SUBJECT: Forwards remaining responses to NRC 890106 request for addl info re emergency power sys enhancement project.

Re: Turkey Point Units 3 and 4  
Docket Nos. 50-250 and 50-251  
Request for Additional Information on  
Emergency Power System Enhancement Project  
NRC TAC Nos. 69023 and 69024

RESPONSE TO REQUEST FOR ADDITIONAL INFORMATION  
EMERGENCY POWER SYSTEM ENHANCEMENT PROJECT

FIGURE 1-1  
 EPS ENHANCEMENT PROJECT  
 CIVIL/STRUCTURAL CRITERIA  
 (NOT TO SCALE)

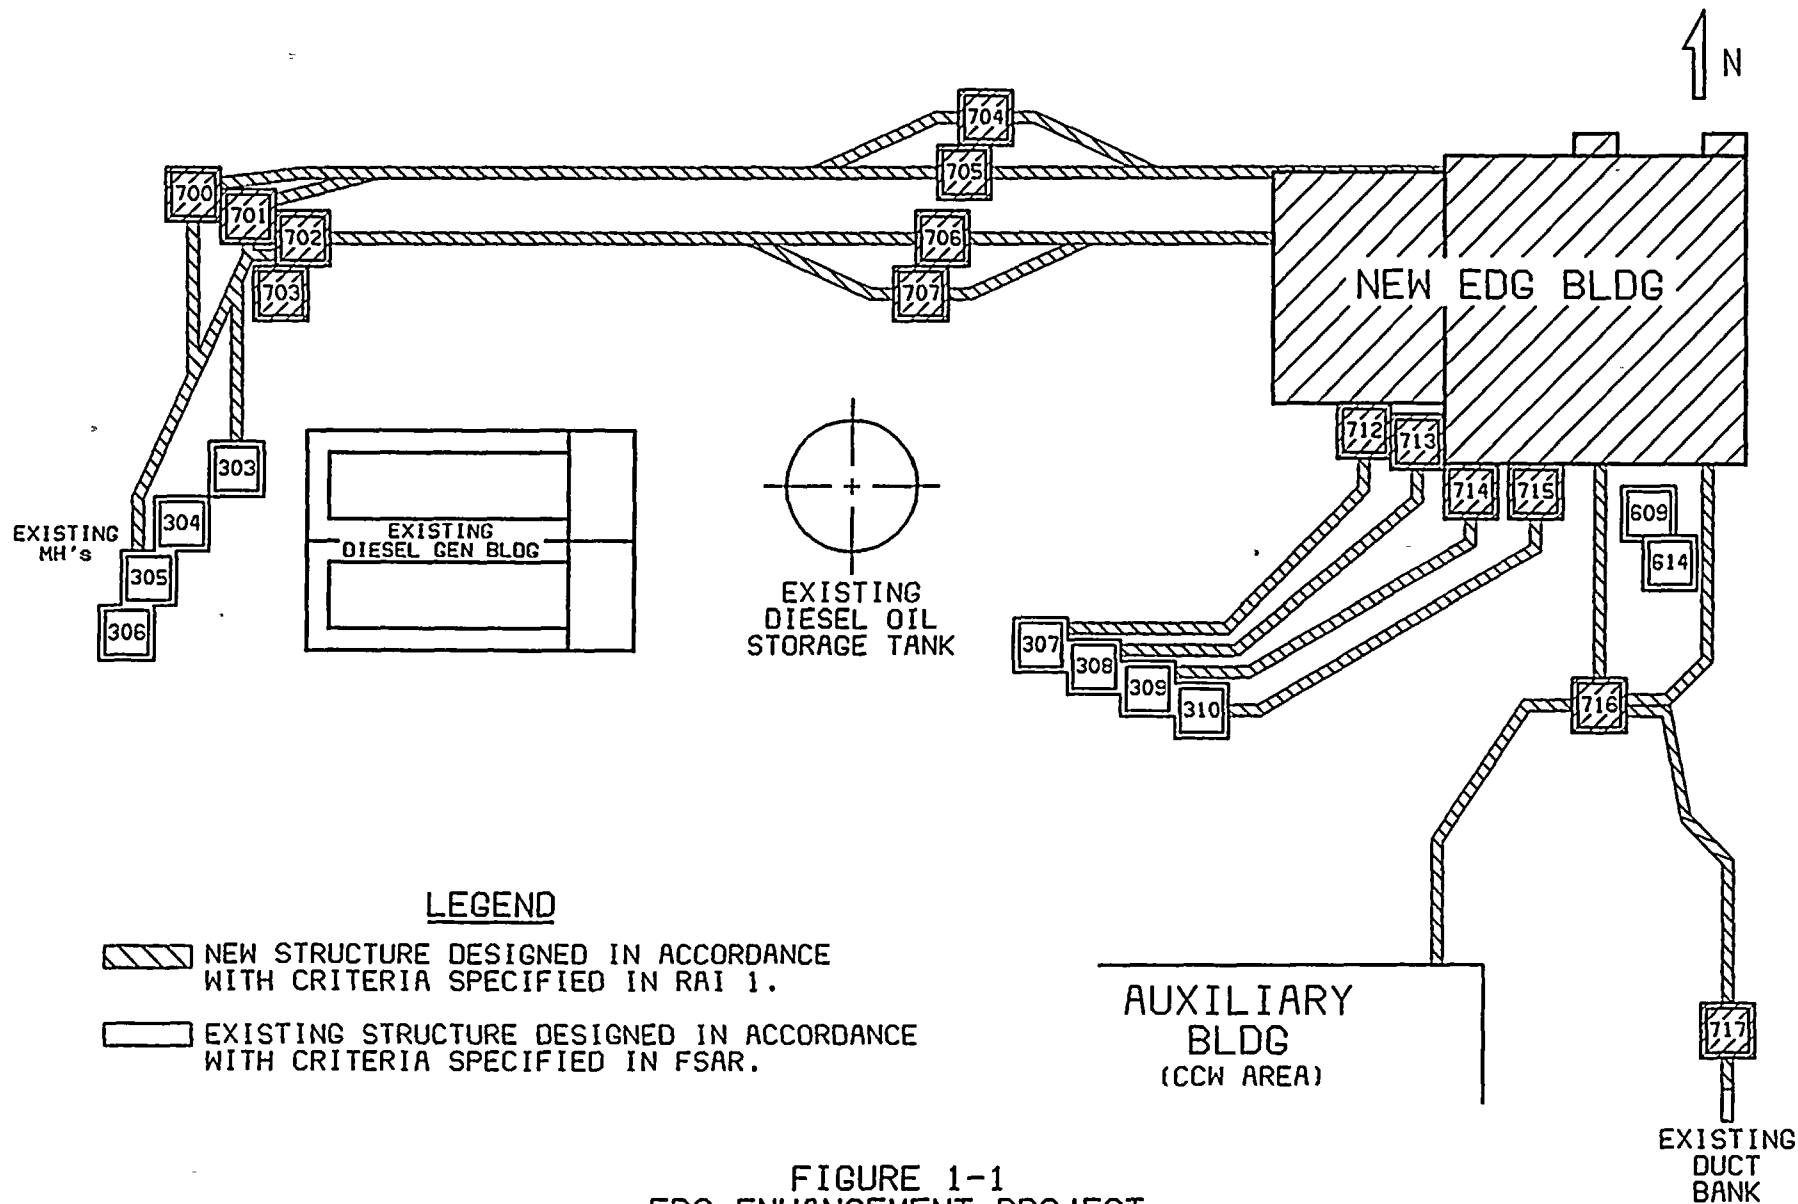
Identify the applicable Codes, Standards, Regulatory Guides, NUREGs, General Design Criteria, Generic Letters, and other documentation (hereafter "Standards") that are to be applied to the system enhancement. For each Standard identified, indicate to which part or parts of the system enhancement that the Standard will apply.

The new EDG building, all internal structures, and all new exterior structures (i.e., ductbanks and manholes) as shown on Figure 1-1 will be designed in accordance with the following criteria. Modifications and additions to existing structures will be designed in accordance with the criteria specified in the FSAR.

Missile protection will be provided for the new EDG building and new exterior ductbanks and manholes shown on Figure 1-1. Missile barriers will be designed to resist penetration and impactive dynamic loading in accordance with the criteria provided in SRP 3.5.3. The following missiles will be considered in barrier design.

FIGURE 32-1  
COOLING SYSTEM HEAT TRANSFER CAPABILITY  
(AT 110% RATED LOAD)

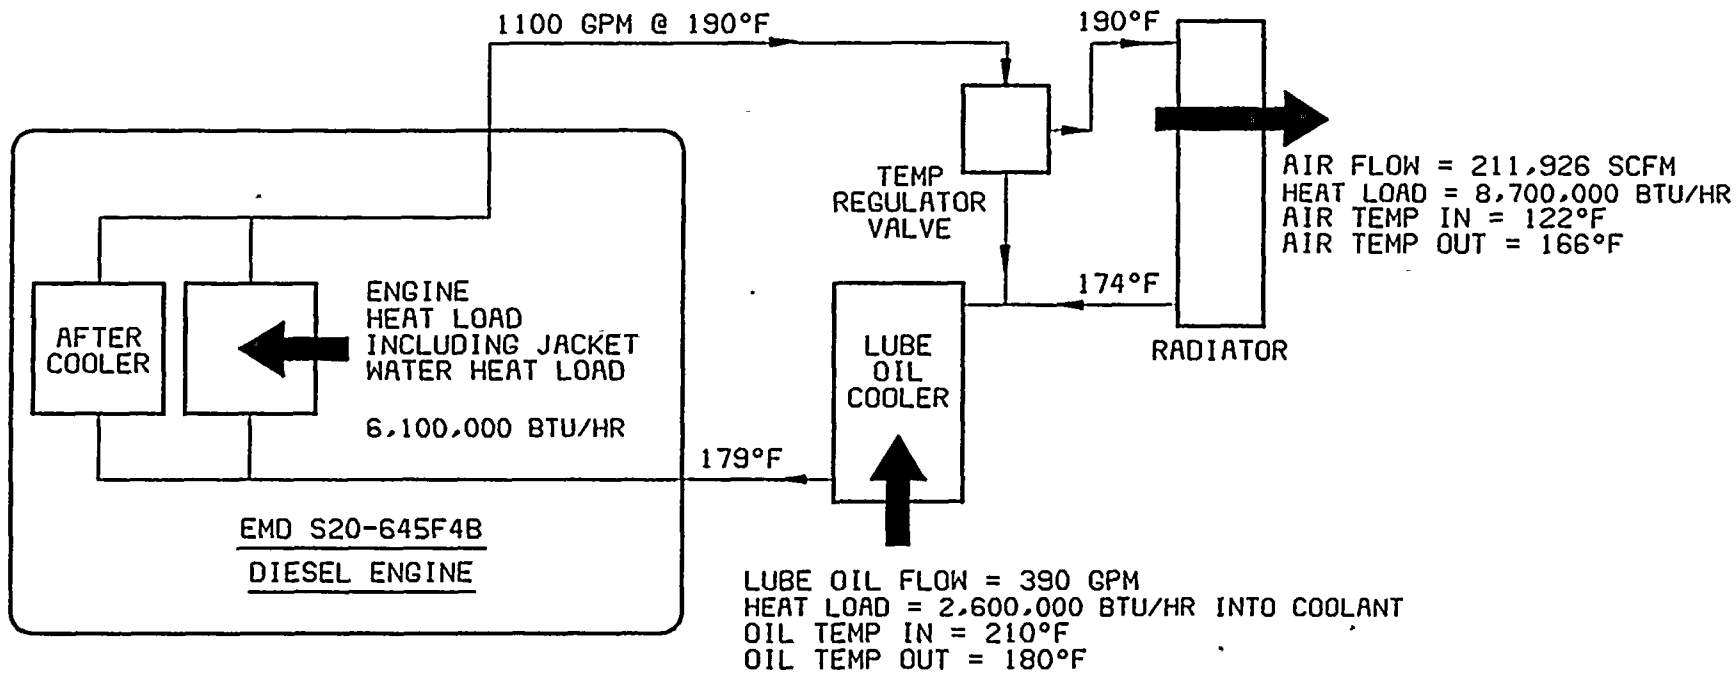
Provide a tabulation showing the individual and total heat removal rates for each major component and subsystem of the diesel generator cooling water system. Discuss the design margin (excess heat removal capability) included in the design of major components and subsystems.

The attached Figure 32-1 identifies the total and individual heat removal rates for the diesel generator cooling water system at 110 percent rated load. The cooling system is designed to maintain a top tank (water leaving the engine) temperature of 190°F at 110 percent rated load and radiator cooling air entering the radiator coils at 122°F. Since the engine is typically not operated at 110 percent rated load, the actual heat removal requirements are lower. The lower actual heat load constitutes design margin for the system.

**FIGURE 37-1**  
**TYPICAL COOLING SYSTEM SCHEMATIC WITH RADIATOR**

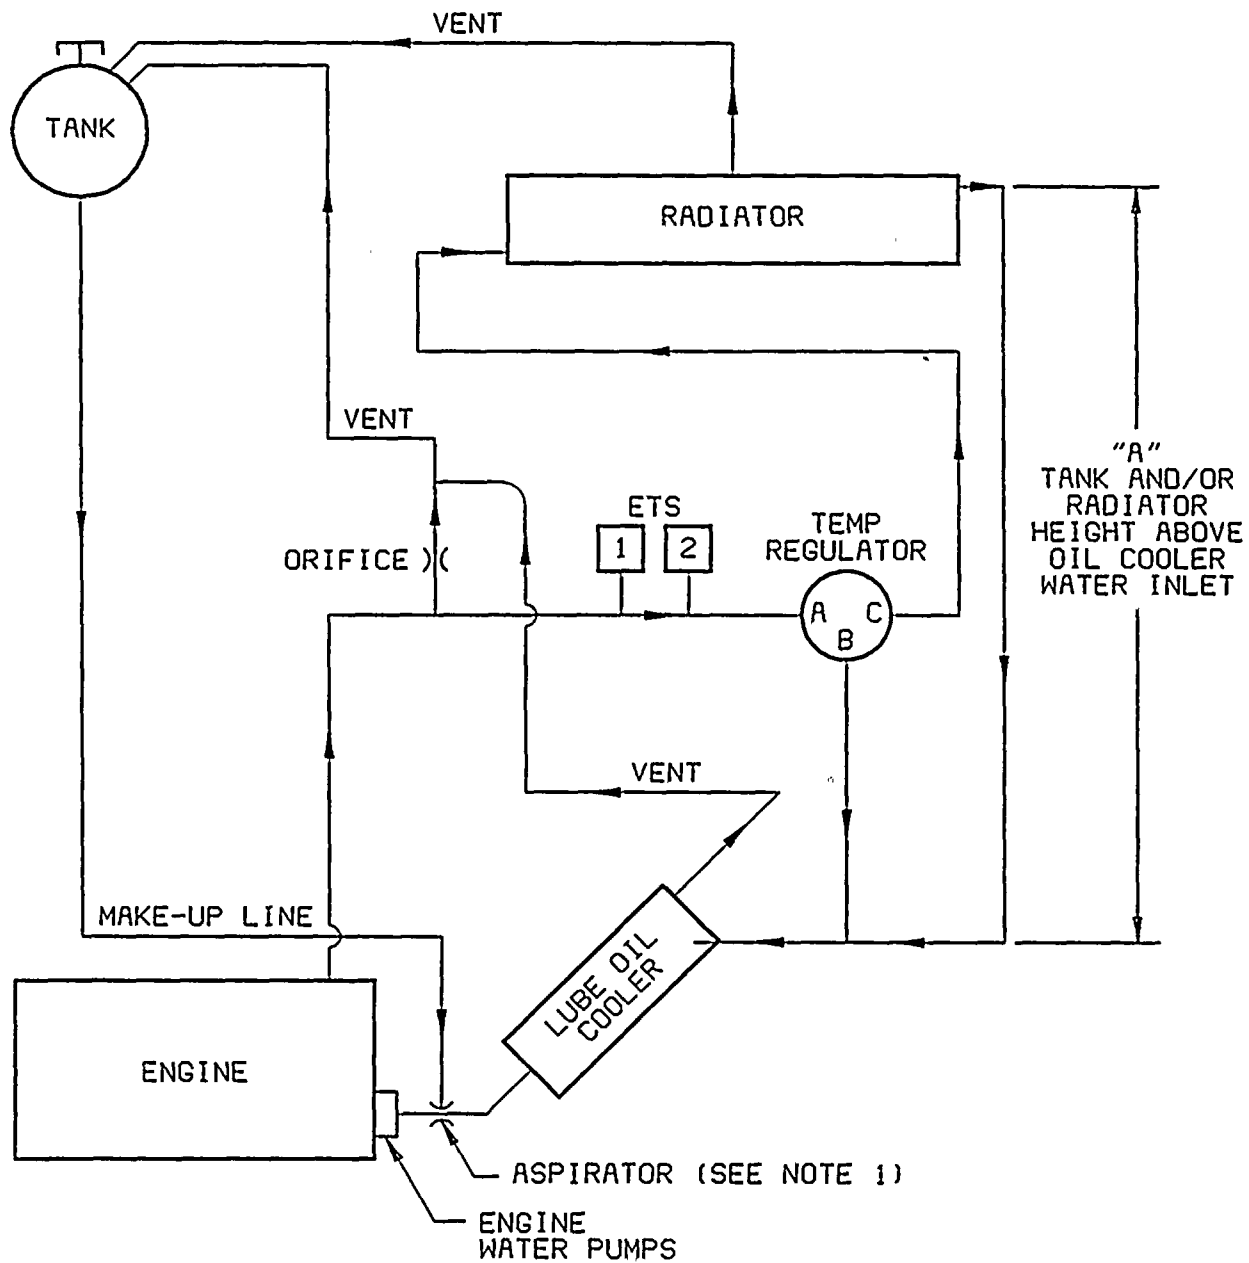
Describe the provisions made in the design of the diesel engine cooling water system to assure that all components and piping are filled with water.

- 1) The minimum height of the expansion tank and radiator relative to the water inlet connection to the lube oil cooler should be 15 feet. Any less height would require the use of aspirators (see Figure 37-1).
- 2) The maximum height of the expansion tank and radiator relative to the water inlet connection to the lube oil cooler should be 25 feet.

- 3) The total pressure loss of pipe and cooling equipment external to the engine accessory rack should be limited to 8 psi.
- 4) To assure that the cooling system is kept completely full of water, the high points of any pipe or component shall be vented to the top of the expansion tank (see Figure 37-1).

The new EDG's comply with each of the above requirements.
